Stage 1 Road Safety Audit and Designer's Response

Report title:	Stage 1 Road Safety Audit Response
Date:	25 April 2025
Document reference and revision	033_8230679_AD_RSA_Response
Prepared by:	Glanville Consultants
On behalf of:	Bloor Homes Southern

Project:	8230679 – Land South of Mortimers Lane, Fair Oak
Report title:	Stage 1 Road Safety Audit Response

Drawing No. 8230679/6107

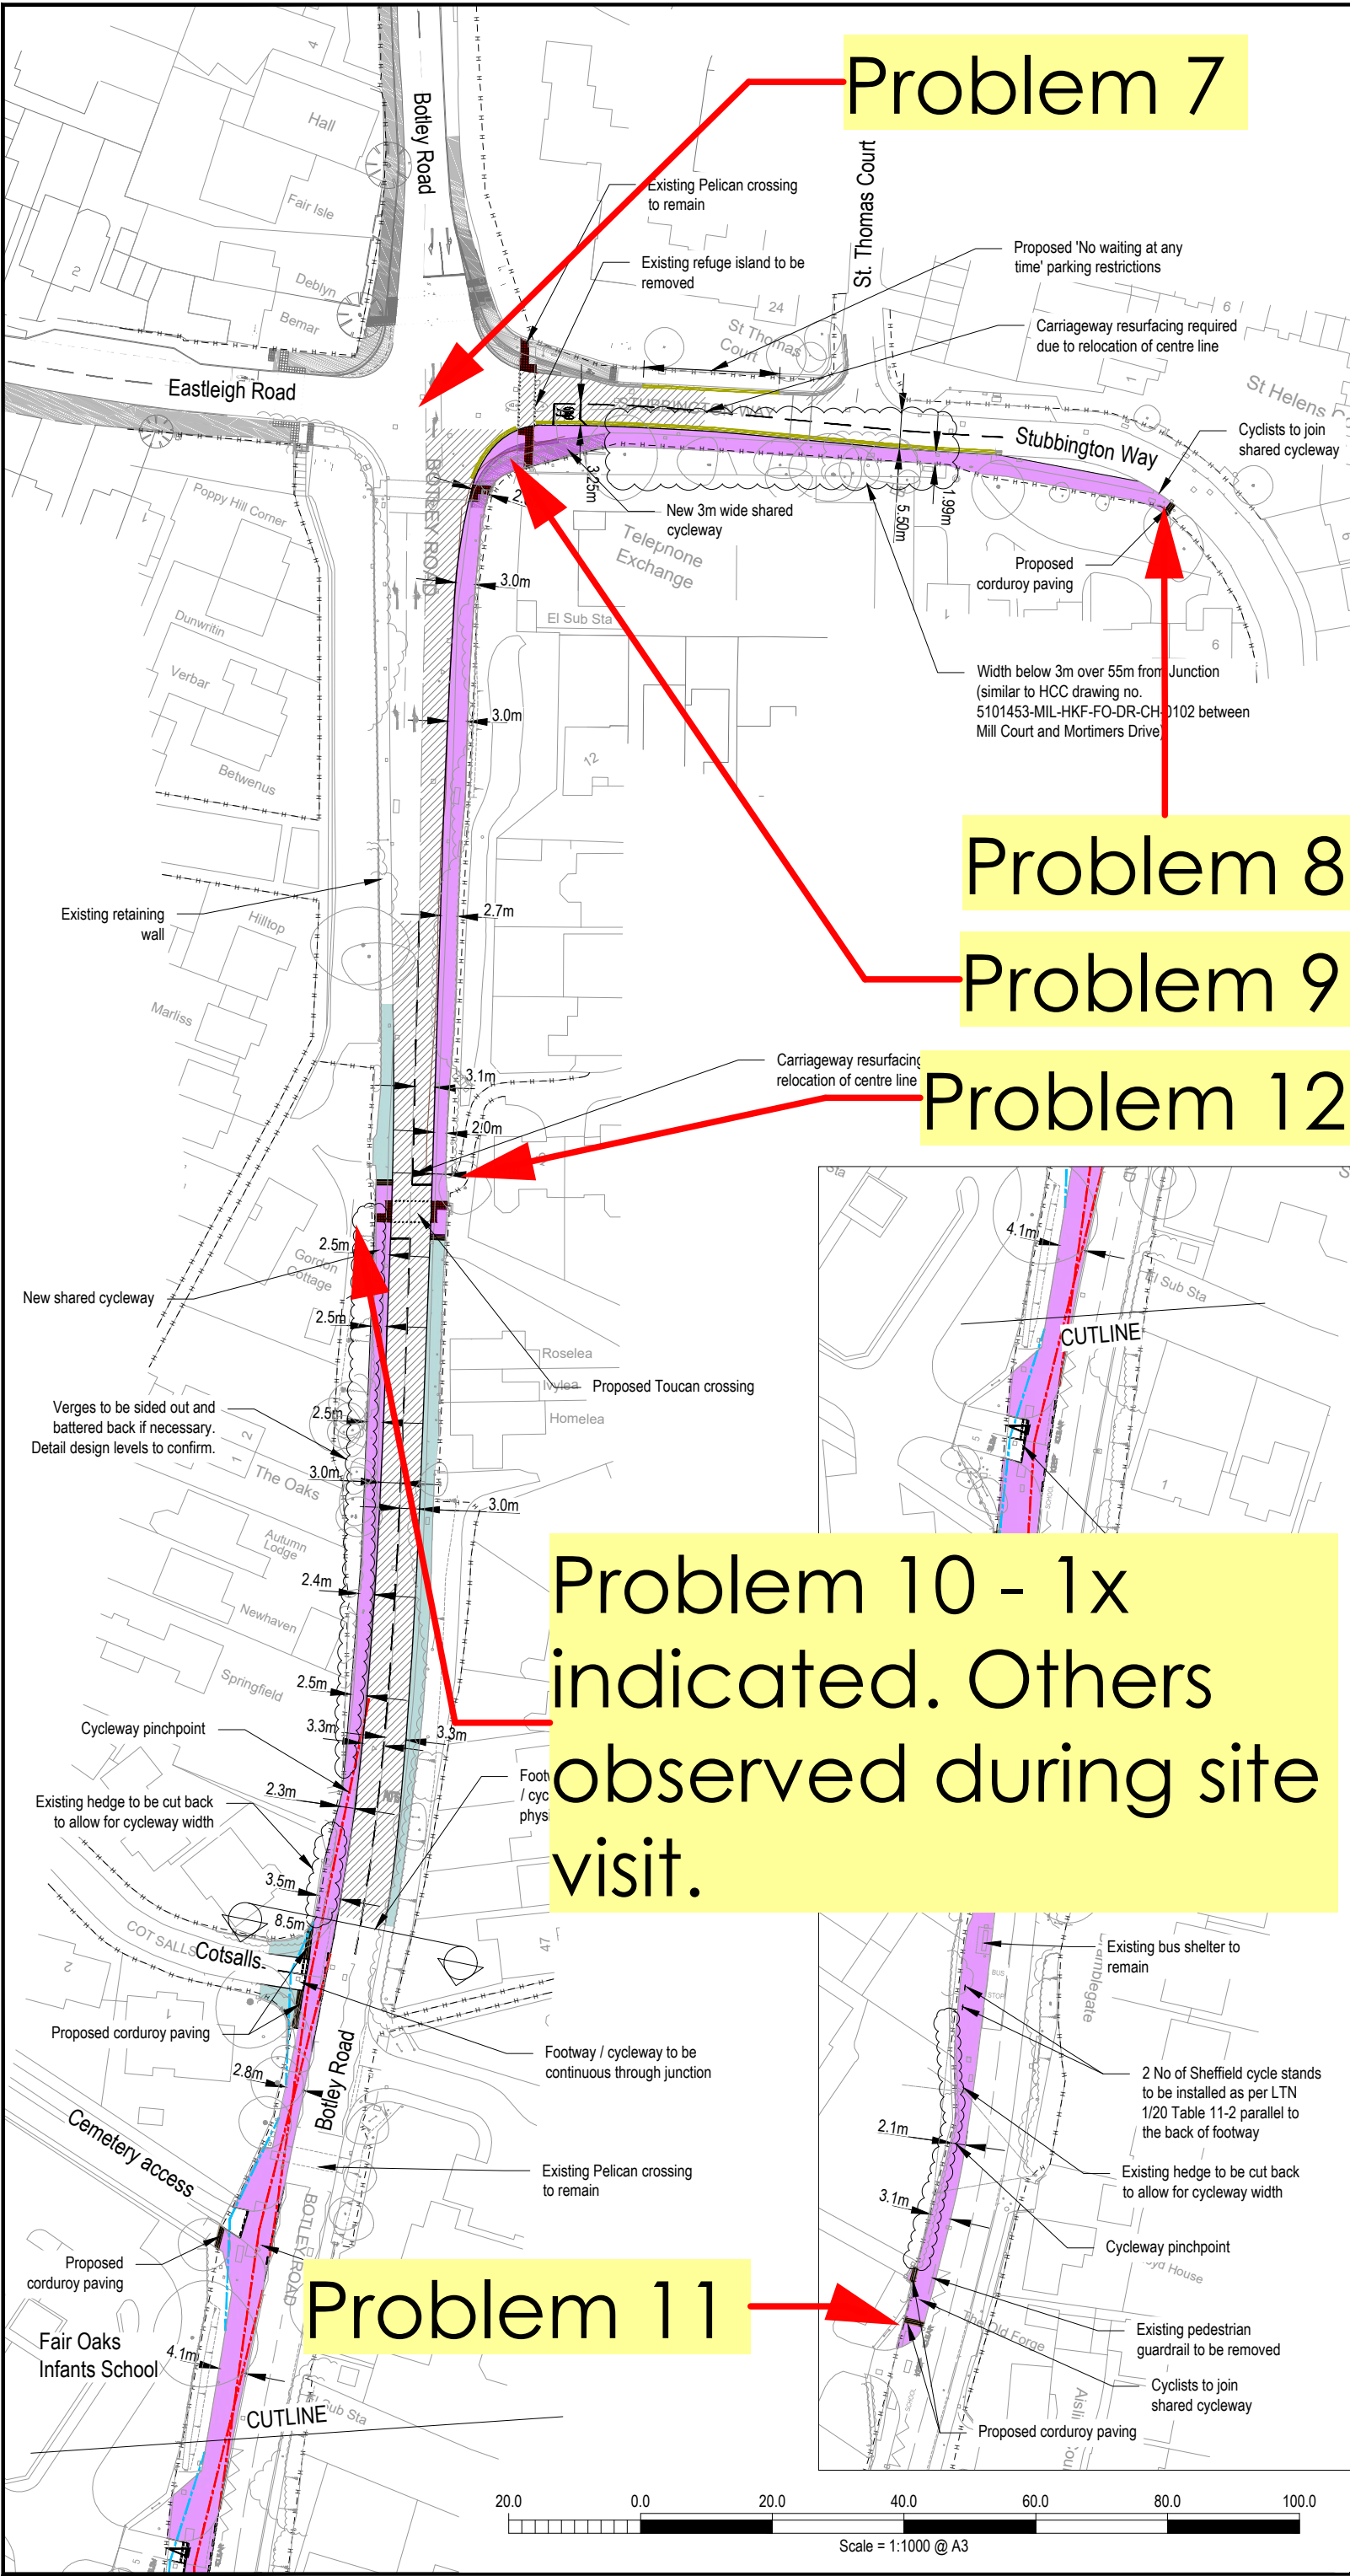
Location: Signalised crossroads at Botley Road / Stubbington Way (Drawing Nos. 8230679/6107 and 6119).

There is a mid-crossing refuge on three of the four arms (excluding Eastleigh Road) at the existing signalised crossroads at Botley Road / Stubbington Way. As part of the proposals the refuges on Botley Road (south) and Stubbington Way will be removed and whilst not indicated on the drawings the same is assumed to apply to Botley Road (north). Currently traffic signals equipment comprising a mixture of off-side primary or closely associated secondary signals are installed within these existing refuges and footways and these will need to be positioned elsewhere as part of the junction modifications. This may result in equipment being positioned within areas of footway or shared facility which may reduce the available width to less than a recommended minimum. In turn this may lead to vulnerable users needing to step into the carriageway with a risk of collisions with vehicles occurring and possible personal injury.

Location: Stubbington Way (Drawing Nos. 8230679/6107 and 6119).

Location: Botley Road (Drawing Nos. 8230679/6107 and 6119).

Location: Botley Road. Commencement of shared footway / cycleway facility (Drawing Nos. 8230679/6107 and 6119).

RSA Problem Ref.	RSA Problem	RSA Recommendation	Design Organisation Response	Overseeing Organisation Response	Agreed RSA Action
9	Owing to the near 90-degree bend on the corner of Stubbington Way / Botley Road (south) and the resultant reduced forward visibility there is a concern that cyclist / cyclist or cyclist / pedestrian collisions may occur. This may lead to personal injury.	It is recommended that forward visibility, commensurate with an appropriate cycling speed should be provided on both approaches to this corner.	17m forward visibility splays (LTN 1/20, 20kph) have been shown around the bend from Stubbington Way onto Botley Road and vice-versa, on drawing 8230679/6119_A. To achieve these splays, an existing road sign will need to be slightly repositioned, the exact location will be determined at detailed design stage.		
10	There are several direct accesses (e.g. to private properties) along both sides of Botley Road. At some of these accesses there will be limited visibility to the left and right on exit, owing to boundary features such as landscaping and / or walls / fencing. Where there is limited visibility a driver exiting their property may not observe an approaching cyclist, who is likely to be travelling faster than a pedestrian. This may lead to cyclist / vehicle collision with possible personal injury.	It is recommended that a vehicle / cyclist intervisibility envelope should be plotted. Where an appropriate intervisibility cannot be achieved measures should be undertaken to ensure that priorities are clearly defined. This may be achieved using give-way road markings.	Visibility splays of 2.4m x 17m (LTN 1/20, 20kph) have been provided from any direct accesses which front onto the shared use facility. At any direct accesses where these visibility splays cannot be achieved, give-way markings have been provided to define user priorities.
